From: "Hannah Flynn" <hannah@northpointplanning.com.au>
Sent: Mon, 13 Apr 2026 09:34:47 +1000
To: "Jake Kidner" <jake.kidner@townsville.qld.gov.au>
Cc: "Meredith Hutton" <meredith@northpointplanning.com.au>; "Development Assessment" <developmentassessment@townsville.qld.gov.au>
Subject: NP23.064 - MCU26/0016 - Information Request - 772 Black River Road, Black River
Attachments: ONP23.064 - IR Response.pdf

Response to Information Request Development Application for Material Change of Use – Tourist Park 772 Black River Road, Black River and formally identified as Lot 24 on SP305779

Application no:	MCU26/0016
Assessment no:	10303058
Proposal:	Tourist Park - Expansion of Existing Site - Stage 2
Street address:	772 Black River Road BLACK RIVER QLD 4818
Real property description:	Lot 24 SP 305779
Applicant's reference:	NP23.064

TRAFFIC IMPACT ASSESSMENT

Figure 3: Turn Warrant Assessment (RPDM)

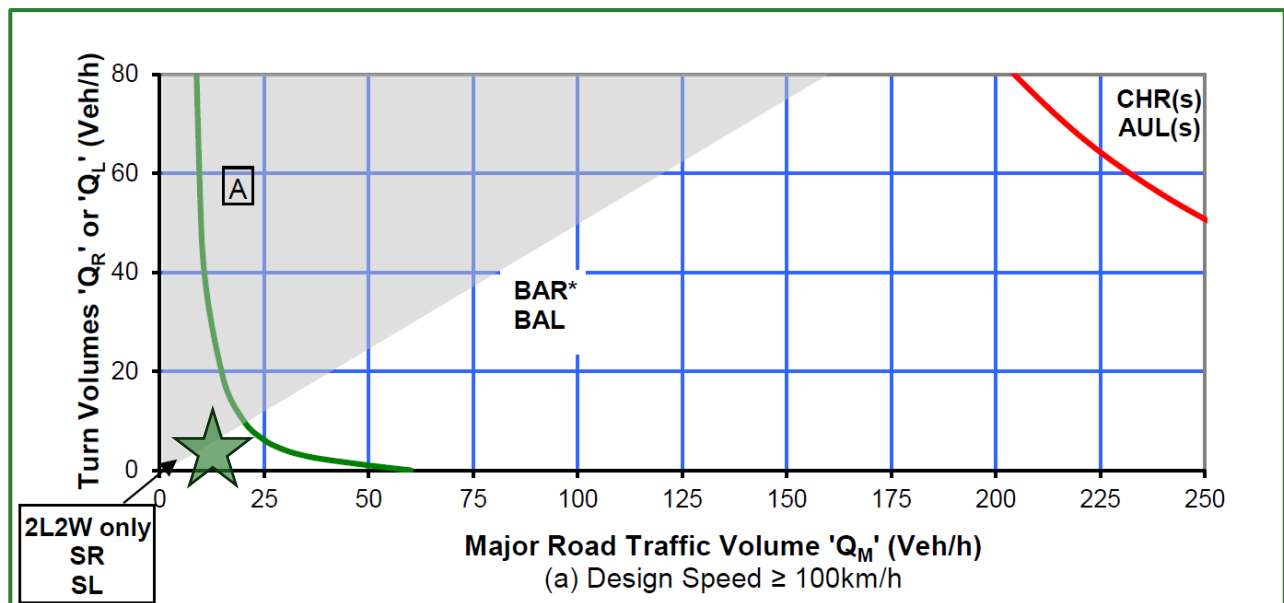
- Address site access safety including adequate sight line clearances and impacts on existing traffic facilities such as heavy vehicle turning paths.
- Confirm that sufficient queuing capacity is provided at the site access in accordance with the RTA's Guide to Traffic Generating Developments.
- Consider and recommend a Basic Right Turn Treatment (shoulder widening opposite the access point), as this represents the typical AUSTRROADS minimum standard.

As detailed in Section 3, the development is anticipated to generate no more than seven (7) vehicle movements in each of the AM and PM peak periods, with only a small proportion of these movements involving right-turn manoeuvres into or out of the site. Peak hour right-turn volumes are therefore extremely low and would occur as isolated events, rather than representing sustained turning demand.

Turn treatment requirements were also reviewed against the Department of Transport and Main Roads' Road Planning and Design Manual (RPDM) Part 4A, which serves as the Queensland supplement to the Austroads Guide to Road Design Part 4A.

While a Basic Right Turn Treatment is identified as a typical treatment for higher-volume rural intersections, the AGRD and RPDM expressly adopt a context- and volume-based approach, and do not mandate auxiliary turn lanes where turning demand and through traffic volumes are demonstrably low.

When the peak turning demand of seven (7) vehicles per hour is assessed against a background through volume of approximately ten (10) vehicles per hour using Figure A.11(a) for design speeds ≥ 100 km/h (see Figure 3), the access operates well within the intended serviceability limits for simple left-turn and simple right-turn movements. Accordingly, no additional turn lane treatments (such as a basic left or basic right turn) are required, and the existing access arrangement is considered appropriate to safely accommodate the expected turning movements without additional infrastructure works from a traffic engineering

perspective. Specifically, provision of a Basic Right Turn Treatment for a peak right-turn demand of approximately two (2) vehicles per hour would represent a disproportionate response to the identified traffic impacts.

In summary, the very low turning and through traffic volumes mean the access operates safely and comfortably within the thresholds for simple left and simple right turn movements, and no additional turn treatment is warranted.
